NUCLEAR PRODUCT ADVISORY:

BARTON 763/763A/764 Transmitter Heat Rise and Qualified Life

DOCUMENT NO.: 210316064.2

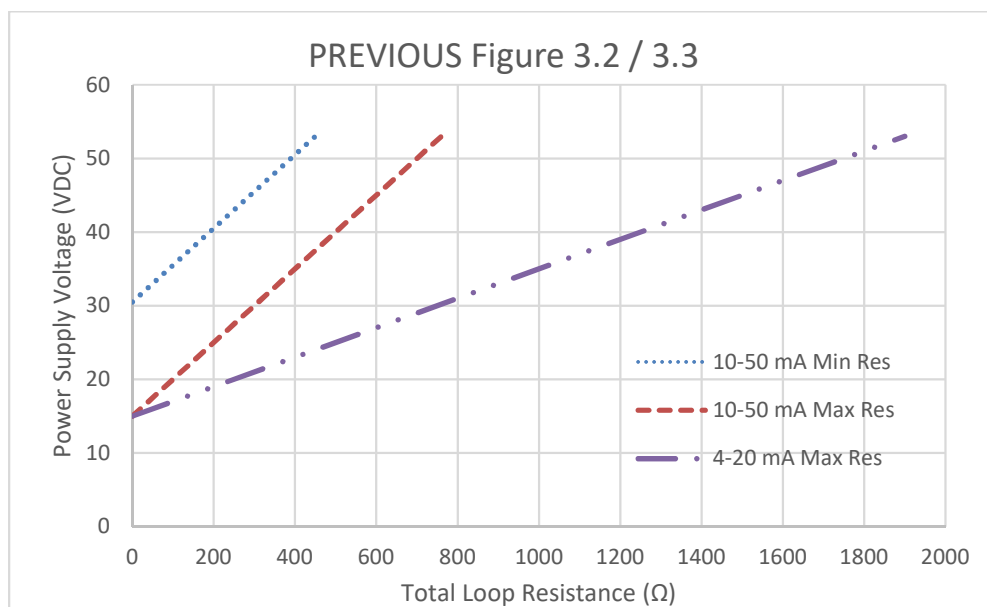
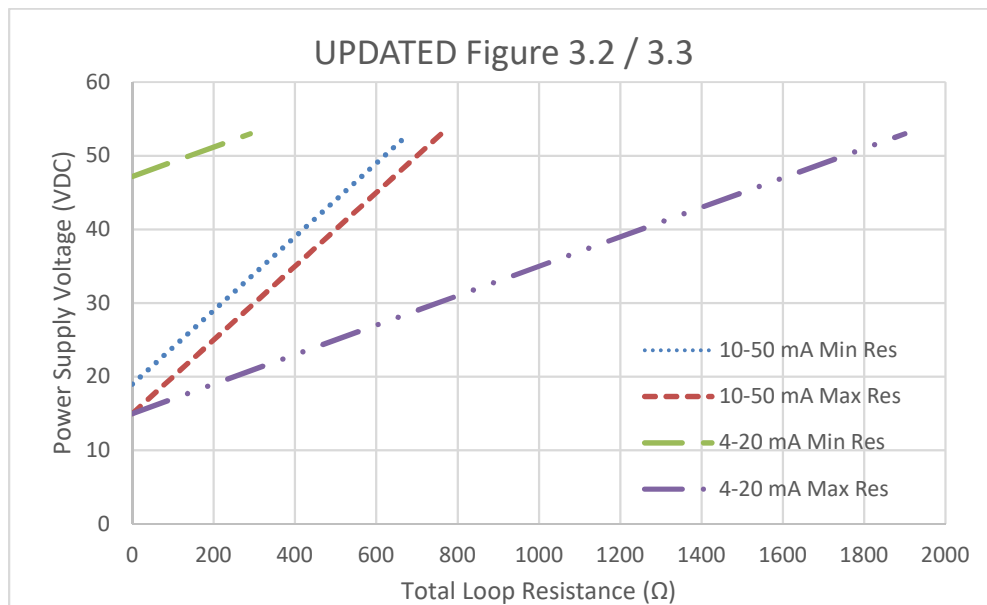
Due to the potential for significant reductions in qualified life, Cameron recommends re-evaluating customer loop installations to ensure power supply and total line resistances comply with the updated figures as provided herein. Compliance with these updated figures will result in maintaining the original life limiting component (R1 metal film resistor), and only a slight reduction in qualified life from 40 years to ~35 years (at 50°C ambient) for all transmitters.

Cameron is in the process of updating the Model 763A and 764 user manuals, which will have updated Figure 3.2 and Figure 3.3 "Power supply v. Total Loop Resistance" figures incorporating heat rise considerations described here. The following two figures show the previous, and updated user manual figures.

NOTE: User manual updated power supply voltage v. total loop resistance Figure 3.2 / 3.3 is based on keeping life limiting component as the metal film resistor accounting for its heat rise. It is based on analysis for 50°C ambient temperature and transmitter operation at continuous full scale (100%) output. Lower ambient temperatures or lower continuous transmitter output would expand acceptable power supply and total loop resistance boundaries while maintaining or improving extrapolated qualified life.

NOTE: The 9A-CR3-763-6 and 9A-CR3-764-9 reports' updated qualified life v. ambient temperature Figure 4-1.B is based on transmitter full scale (100%) output for the entirety of customer installation. Transmitter outputs below 100% will result in increase in qualified life.

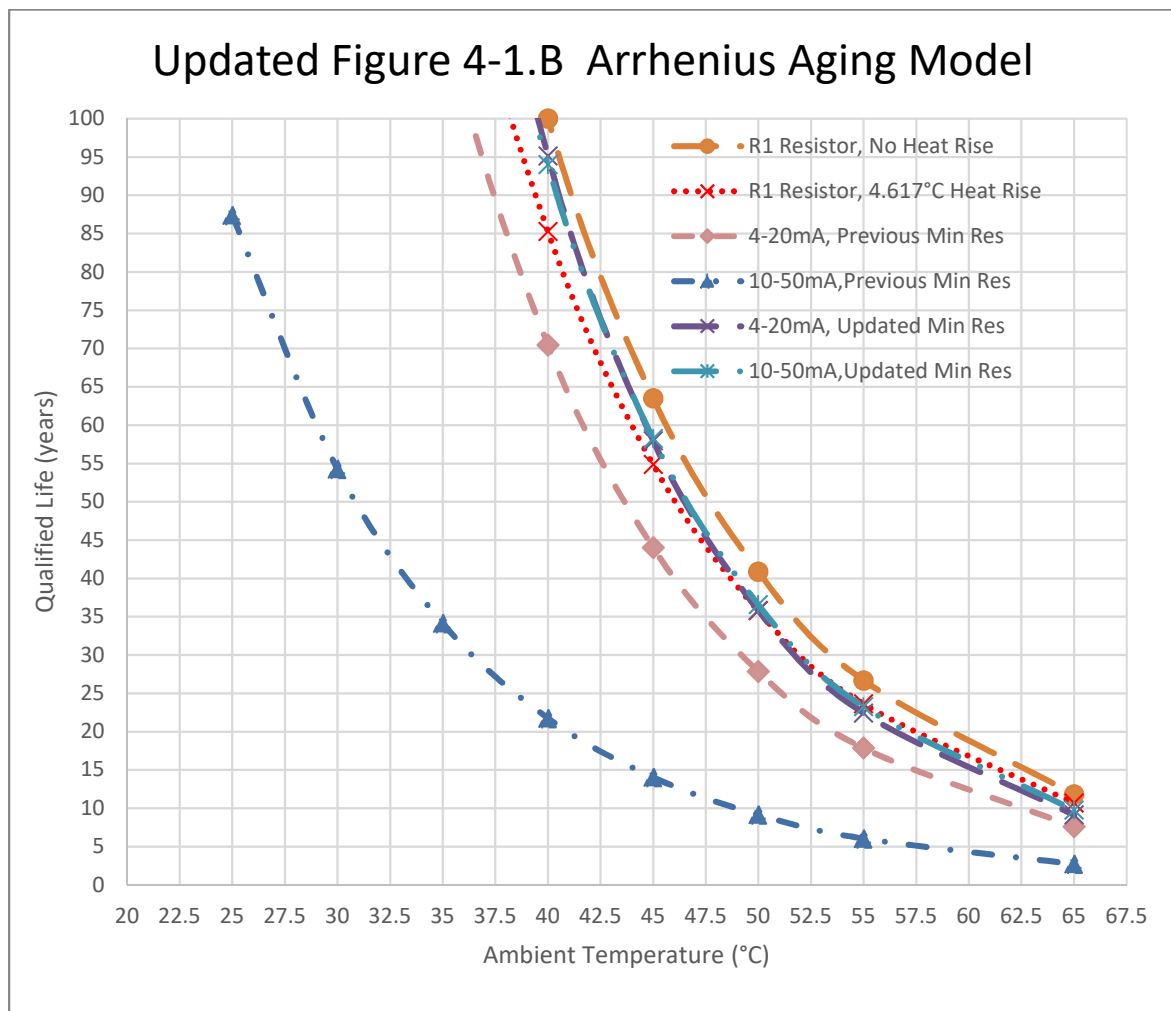
The Barton original report qualified life of 40 years at 50°C ambient temperature will no longer be valid when accounting for heat rise. It will instead be reduced to approximately 35.7 years at the same temperature, based on the heat rise in the R1 resistor. Furthermore, this reduced qualified life is only valid so long as the updated power supply voltage and total line resistance requirements are followed. Due to transistor heat rise considerations, use of the user manual's previously supplied power supply voltage and total line resistance lower limits could possibly result in significant reduction of qualified life if transmitters are continuously operated at full scale (100%) output. For example, for a 4-20 mA circuit operated continuously at 20 mA, qualified life at 50°C ambient could be reduced from 40 years, to 27.8 years. And for a 10-50 mA circuit operated continuously at 50 mA, qualified life at 50°C could be reduced from 40 years to 9.1 years.
